STAFF RECOMMENDATION

1015 Halcyon Avenue

March 17, 2021

Application: New Construction—Infill and Outbuilding
District: Waverly-Belmont Neighborhood Conservation Zoning Overlay
Council District: 17
Base Zoning: R8
Map and Parcel Number: 11801022200
Applicant: Tarl LaRocco
Project Lead: Melissa Sajid, Melissa.sajid@nashville.gov

Figure 1. Vacant lot at 1015 Halcyon Avenue.

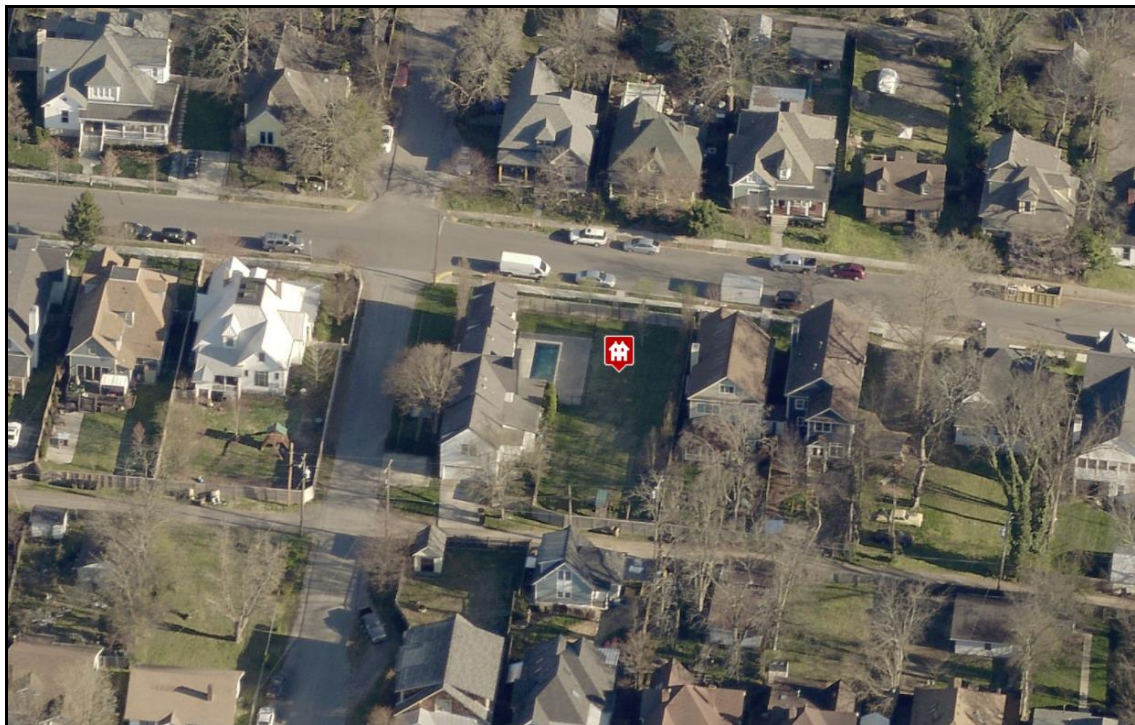
Background: The property located at 1015 Halcyon Avenue is a vacant lot in the Waverly-Belmont neighborhood (Figure 1). In 2016, MHZC staff issued a permit to demolish the non-contributing house that previously stood on the lot.

1015 HALCYON AVENUE
SIDE ELEVATIONS • SCALE: 1/8"=1'

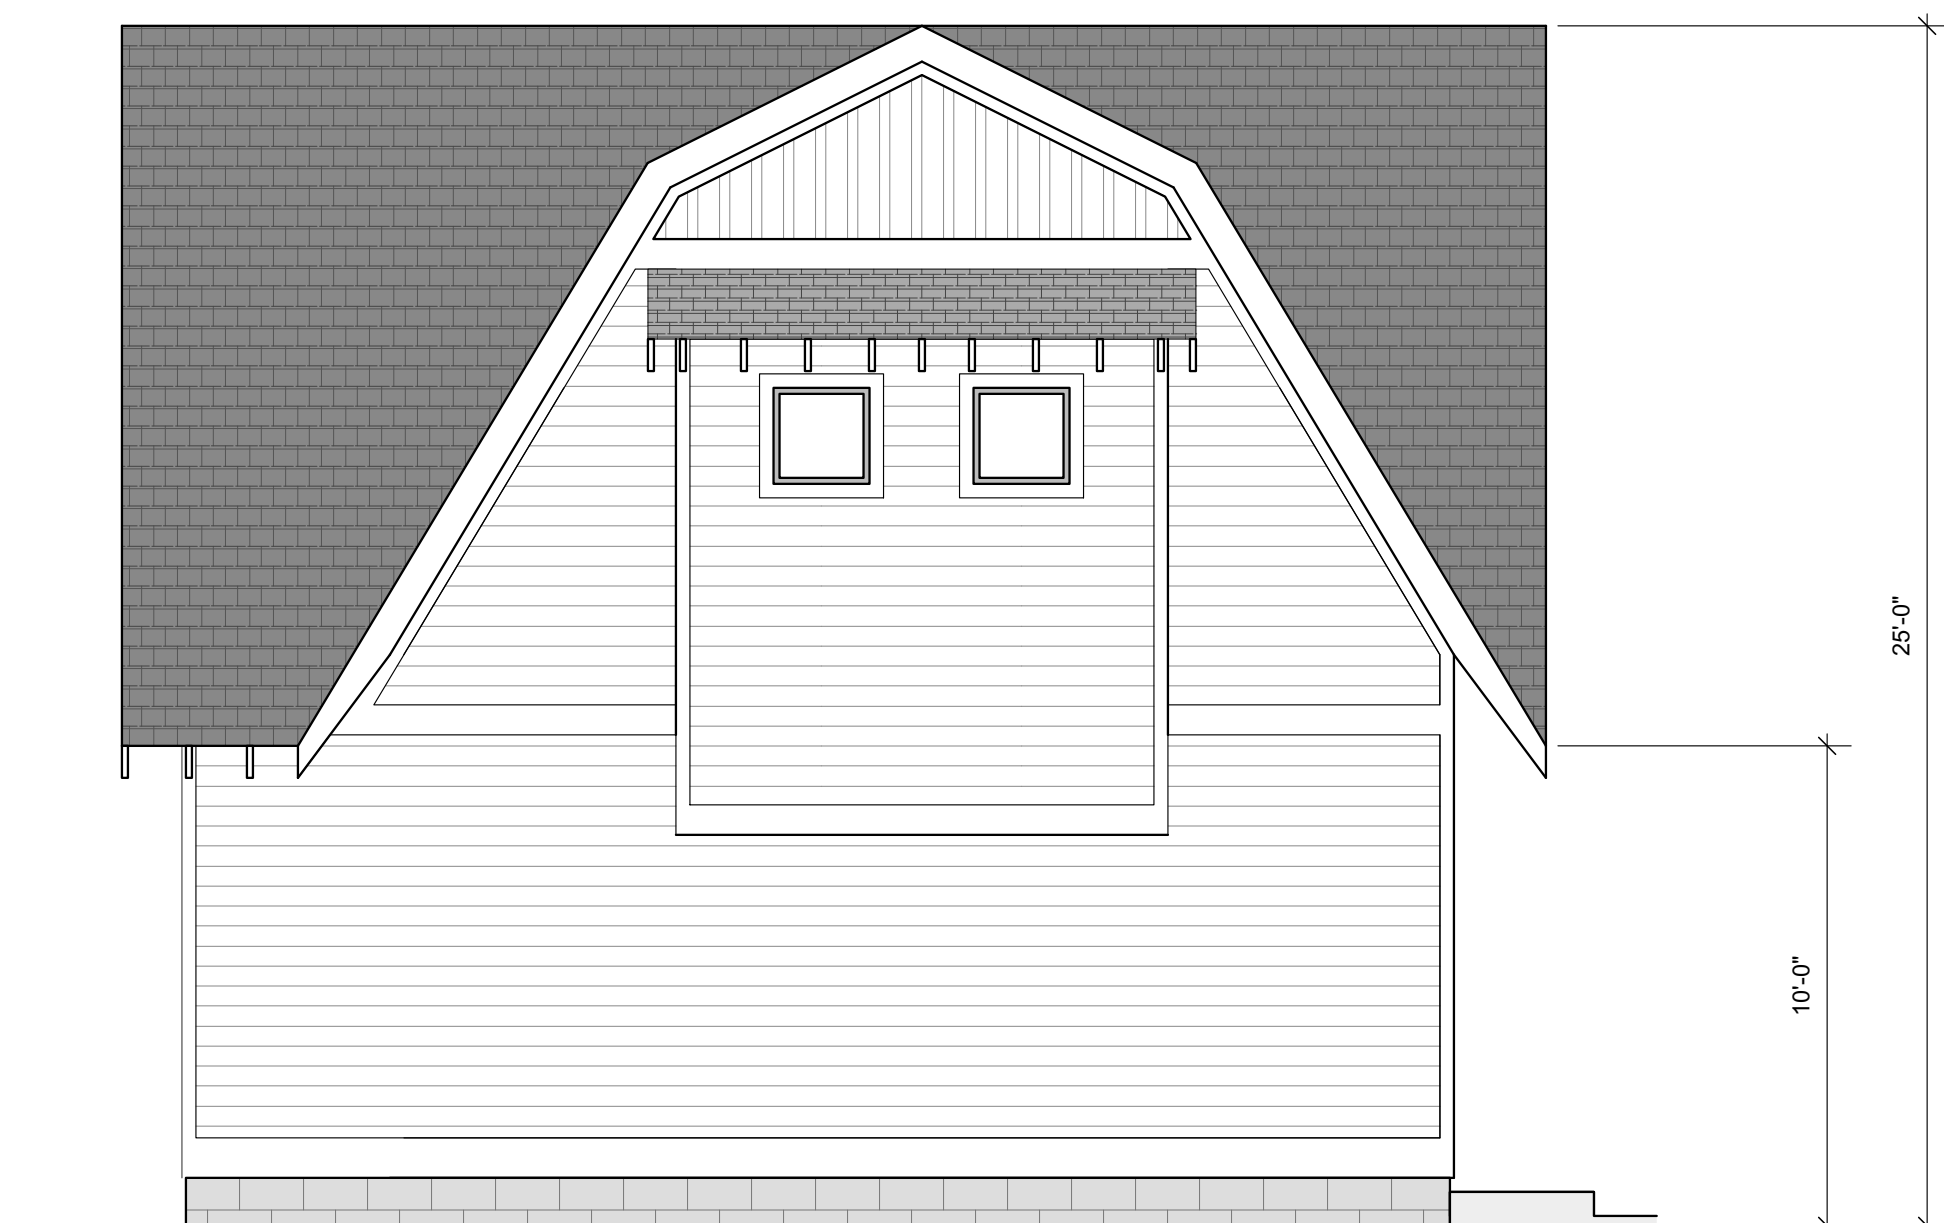
Height & Scale: The proposed infill will be one and one-half stories with an eave height of approximately fifteen feet (15') at the front from grade, a ridge height of approximately twenty-six feet, ten inches (26'-10"), and a foundation height of approximately one foot, six inches (1'-6"). The subject property is a flat lot whereas historic homes on the block include cross-slopes of varying degrees. The proposed foundation height appears to be similar to that of infill at 1011 Halcyon Avenue. Staff finds that the infill's height meets the historic context where houses range in height from approximately twenty-four feet to twenty-seven feet (24'-27') from grade and that the eave and foundations heights are compatible with the historic context.

The building is thirty-four feet, eight inches (34'-8") wide and includes a single-story projection on the right-side that extends approximately eight inches (8") wider. The projection is located approximately twenty-six feet (26') beyond the front wall. This is in keeping with the neighboring context, which ranges between approximately thirty and thirty-six feet (30'-36') wide. The infill has a depth of sixty-eight feet, four inches (68'-4"), not including the covered stoop. The proposed depth of the infill is similar to the depth of nearby historic homes with rear additions.

Most of the known materials meet the design guidelines. The infill proposes brick to grade on the primary massing of the infill as well as a front knee wall surrounding the porch floor. The Commission has typically required a different foundation material to delineate the foundation line. Staff recommends that the infill incorporate a different material for the foundation. In addition, the site plan should show a front walkway connecting the front stoop to the public sidewalk. With the conditions that there be a change of material at the foundation, that the site plan show the walkway, and that staff review the final details of the doors, roof material and color, and a masonry sample prior to purchase and installation, staff finds that the project meets Section III.D.

Roof form: The infill has a side gabled roof form with a 6/12 pitch and incorporates a 14/12 front gable that is not attached at the peak to the primary roof form. The rear of the infill reads like a rear gabled addition with an 8/12 pitch that also incorporates side shed dormers that are inset appropriately and a single-story hipped portion on the rear that also has an 8/12 pitch.

Proportion and Rhythm of Openings: Most of the windows on the proposed infill are all generally twice as tall as they are wide, thereby meeting the historic proportions of openings. The dormer on the left-side façade incorporates some smaller square windows; staff finds that these windows can be appropriate since they are located on the side façade beyond the midpoint on a dormer that is inset two feet (2') from the primary side wall of the house. There are no large expanses of wall space without a window or door opening.

1. The finished floor height shall be consistent with the finished floor heights of the adjacent historic houses, to be verified by MHZC staff in the field;

2. The front setback shall be verified by MHZC staff in the field after staking;
3. There shall be a change in material for the foundation of the infill;

4. The site plan shall show a front walkway connecting the front door to the public sidewalk;
5. Staff approve the final details, dimensions and materials of doors, roof material and color, and a masonry sample for the infill prior to purchase and installation;

FRONT (STREET) ELEVATION
SCALE: 1/4"= 1'

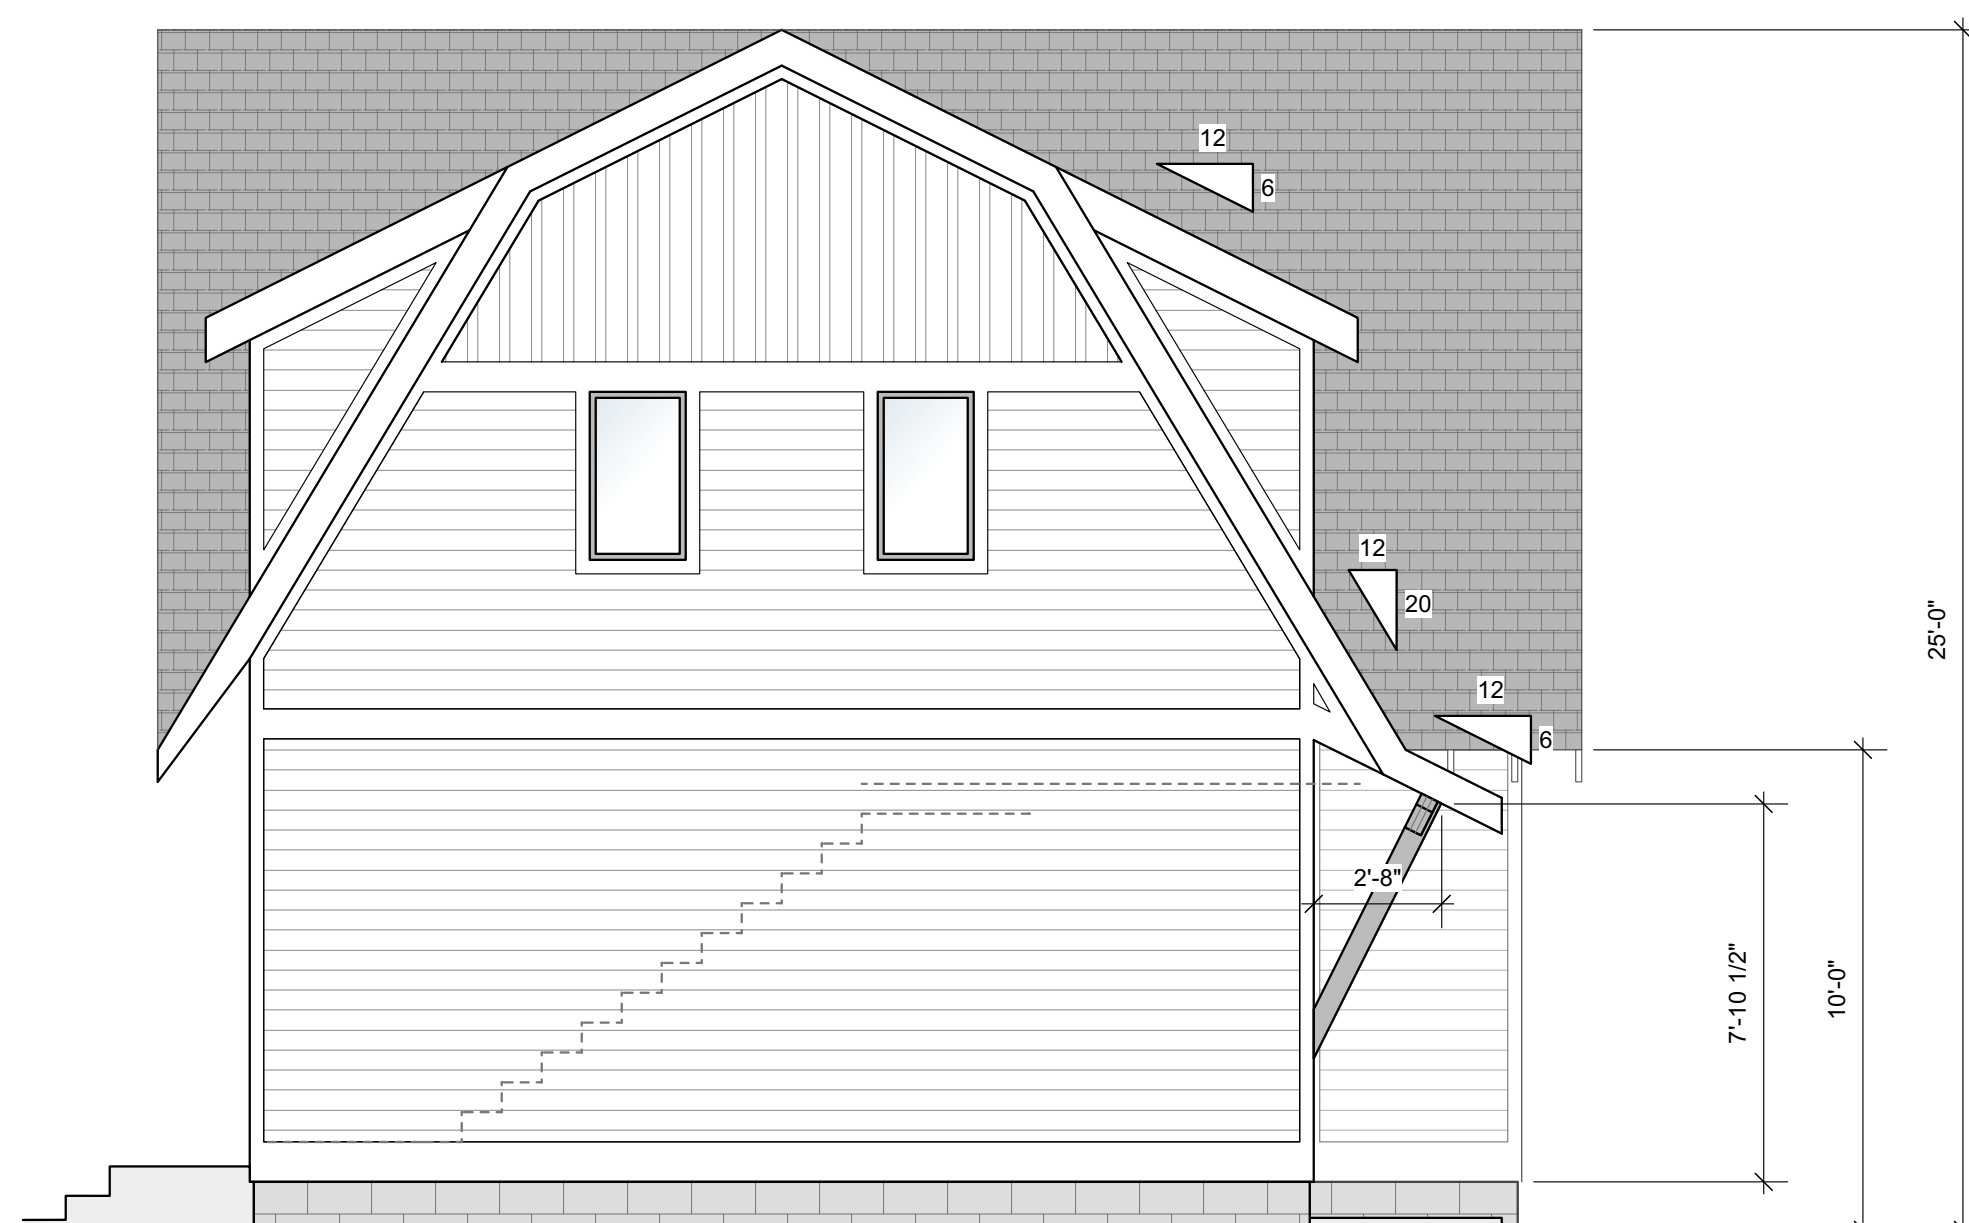
*As proposed, the dormers are not set in from the wall below. However, the Commission has found dormers such as those proposed on this outbuilding to be appropriate when the outbuilding has a gambrel roof form.

*The proposed outbuilding has a gambrel roof form, which is not common in the neighborhood, but it is seen historically and has been approved by the Commission in the Waverly-Belmont district and the neighboring Belmont-Hillsboro district. The outbuilding incorporates dormers on the front and rear elevations. The dormers do not exceed fifty percent (50%) of the roof plane. The Commission has required dormers to sit at least two feet (2') back from the first-floor wall; however, on a gambrel form, that is not possible. The Commission has approved a couple of outbuildings that have a gambrel roof form with dormers that stack on the wall below, so staff finds that the proposed dormers stacking the wall below is appropriate in this case.

The proposed structure has a simple design that is appropriate for outbuildings. The form and detailing do not contrast greatly with the proposed infill.

6. Staff approved the roof color, windows, doors, and garage doors for the outbuilding prior to purchase and installation; and,
7. The HVAC shall be located behind the house or on either side, beyond the mid-point of the house, and utility meters shall be located on the side of the building, within 5’ of the front corner. Alternative mechanical and utility locations must be approved prior to an administrative sign-off on building permit(s).
